Work Order ID 159219

Item Name: Crosstube Assembly, Mid Aft

DART AEROSPACE LTD	Work Order:	159219
Description: Crosstube Assembly, Mid Aft	Part Number:	D206-667-247
Inspection Dwg: D206-667-247 Rev: A		Page 1 of 2

DRAWING NO. D206-667-247	TITLE CROSSTUBE ASS'Y (206L MID AFT)	REV. A	DART AEROSPACE LTD ENGINEERING ORDER		D.E.O. NO. D206-667-247-A-1	SHEET NO. SHEET 1 OF 1	SCALE NTS
DRAWN <i>QD</i>	CHECKED <i>ASS</i>	MFG. APPR. <i>KB</i>	APPROVED <i>IMP</i>		DE APPR. <i>#</i>		
DATE 11.07.15	DATE 11.07.20	DATE 11.07.21	DATE 11/07/21		DATE 11.07.21

DRAWING NO. REV. A
D206-667-247 SHEET 1 OF 4

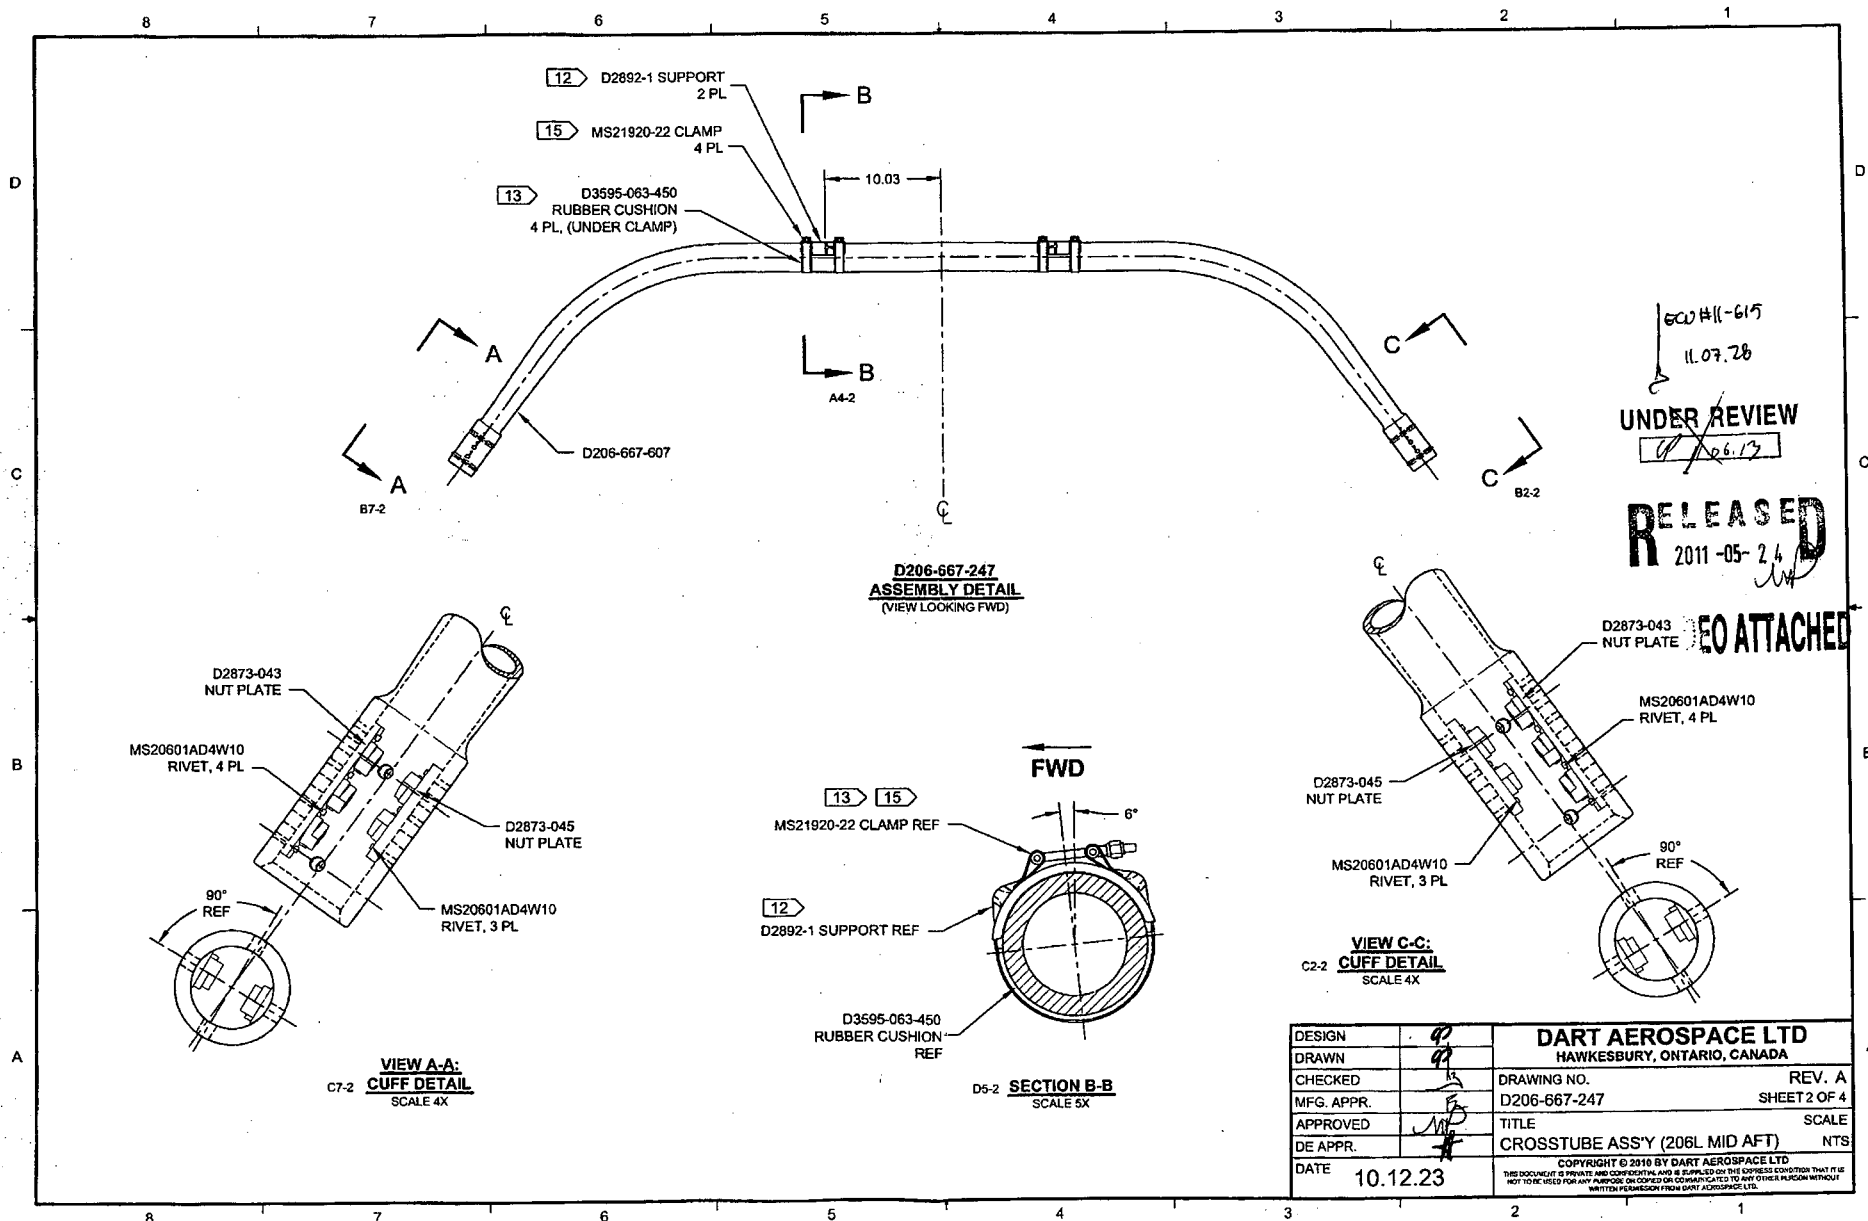
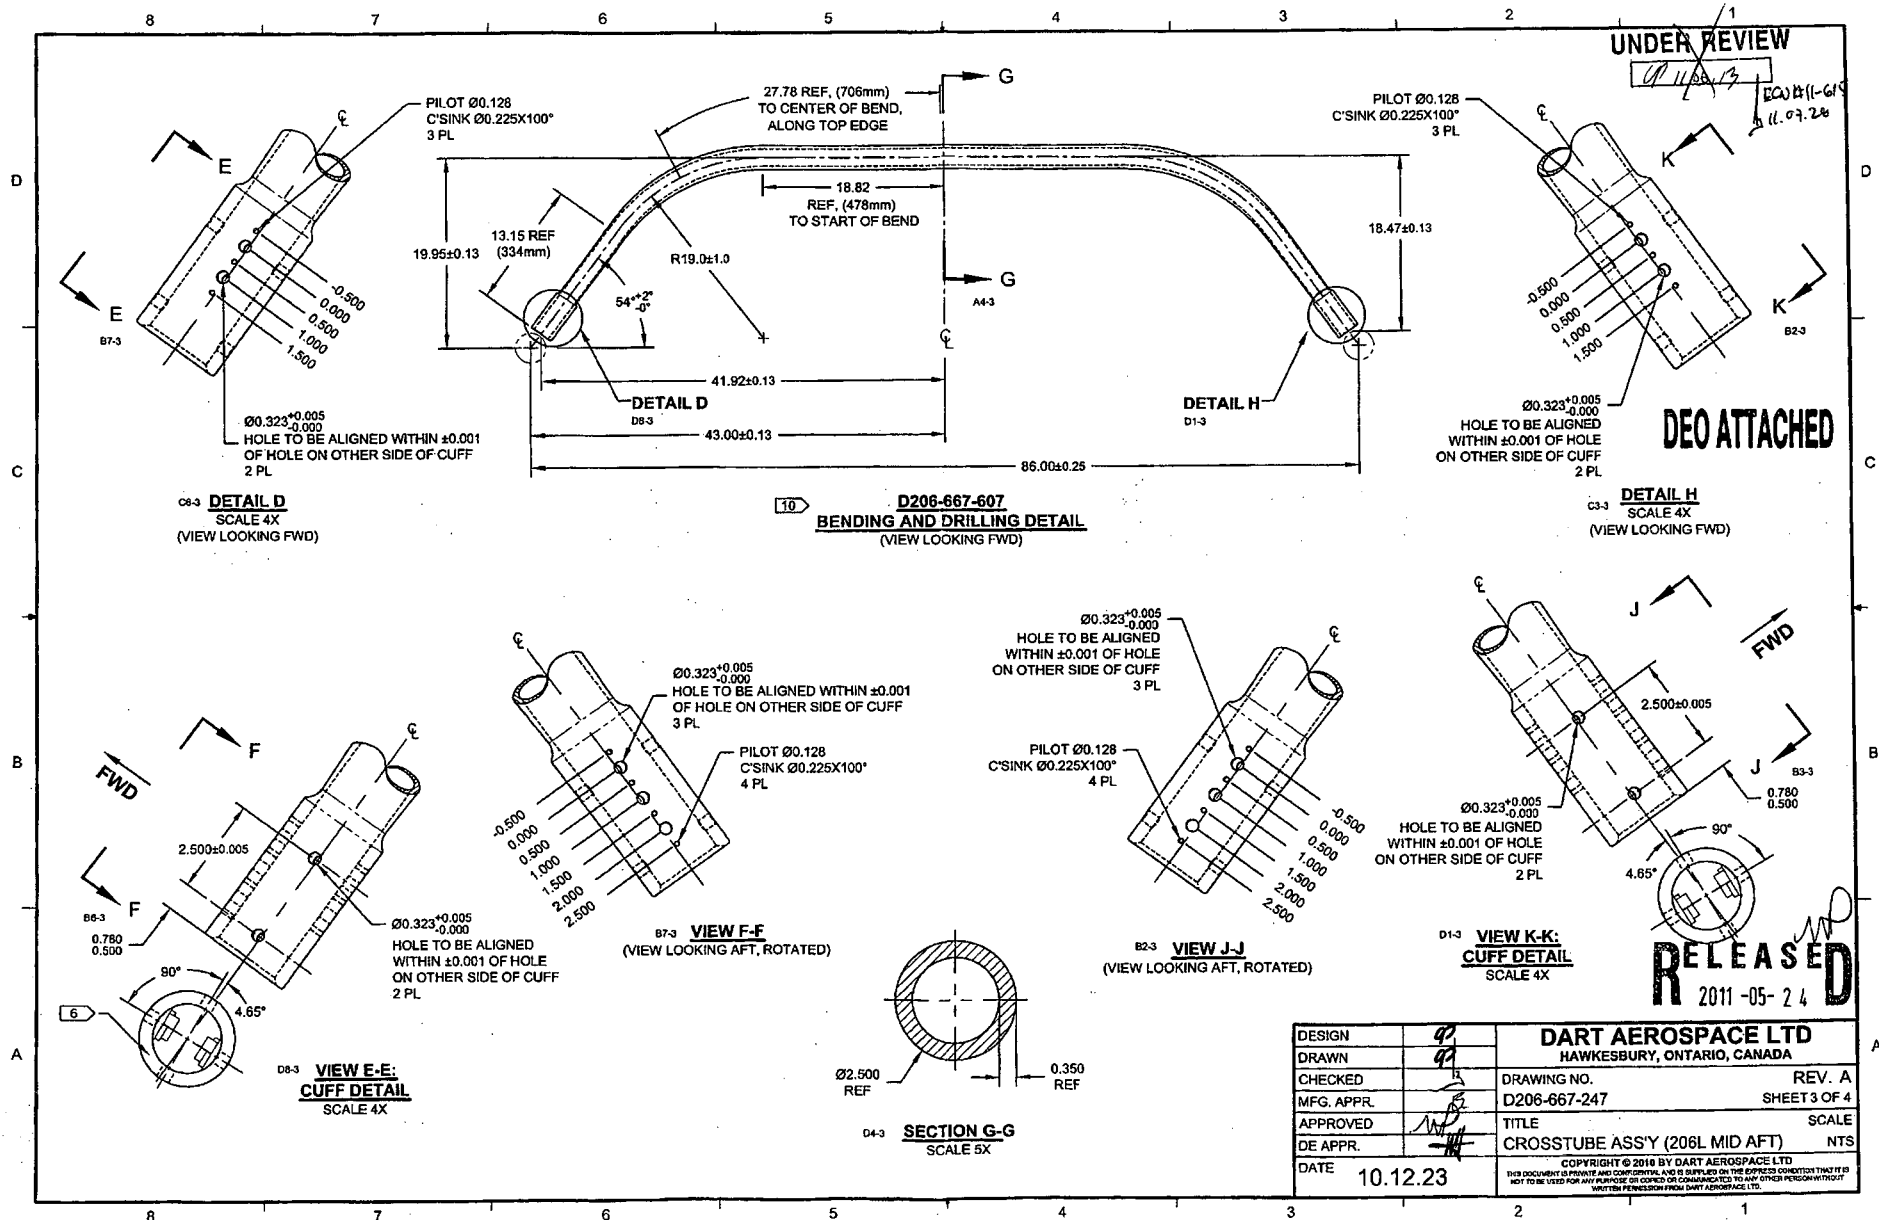
PURPOSE:

REPLACE MAGNOBOND WITH PROSEAL.

Item	Qty -247	Part Number	Description
9	A/R	PROSEAL 890 B-2	SEALANT, AMS-S-8802 CLASS B-2

9	A/R	MAGNOBOND 6398	ROCKWELL SPECIFICATION RBO-120-023 ADHESIVE (TEXTRON/BELL SPEC. 299-947-100, TYPE II, CLASS 2 ADHESIVE)
---	-----	----------------	---

NOTE 12 & 15, SHEET 1 IS AMENDED AS FOLLOWS:

- 12) INSTALL D2892-1 SUPPORT USING 0.03" TO 0.06" THICK LAYER OF MAGNOBOND 6398 PER QSI 015. LET CURE FOR 12 HOURS AFTER INSTALLATION AND PRIOR TO PACKAGING.
- 15) TORQUE CLAMPS 80 TO 100 IN-LB. ENSURE AT LEAST 1.5 THREADS SHOWING IN SAFETY AND THAT NUT HAS NOT BOTTOMED-OUT AFTER TORQUING.

- 12) TO INSTALL D2892-1 SUPPORT: ABRASE MATING SURFACE OF SUPPORT AND CROSSTUBE WITH 180-GRIT SANDPAPER AND REMOVE RESIDUE WITH MEK (OR EQUIVALENT). APPLY A 0.04" TO 0.07" THICK LAYER OF PROSEAL 890 CLASS B-2 (OR AMS-S-8802 CLASS B-2) SEALANT TO MATING SURFACE OF SUPPORT.
- 15) TORQUE CLAMPS 80 TO 100 IN-LB. ENSURE AT LEAST 1.5 THREADS SHOWING IN SAFETY AND THAT NUT HAS NOT BOTTOMED-OUT AFTER TORQUING. **PRIOR TO PACKAGING, RE-CHECK TORQUE ON CLAMPS AFTER PROSEAL 890 SEALANT HAS CURED FOR 72 HOURS.**
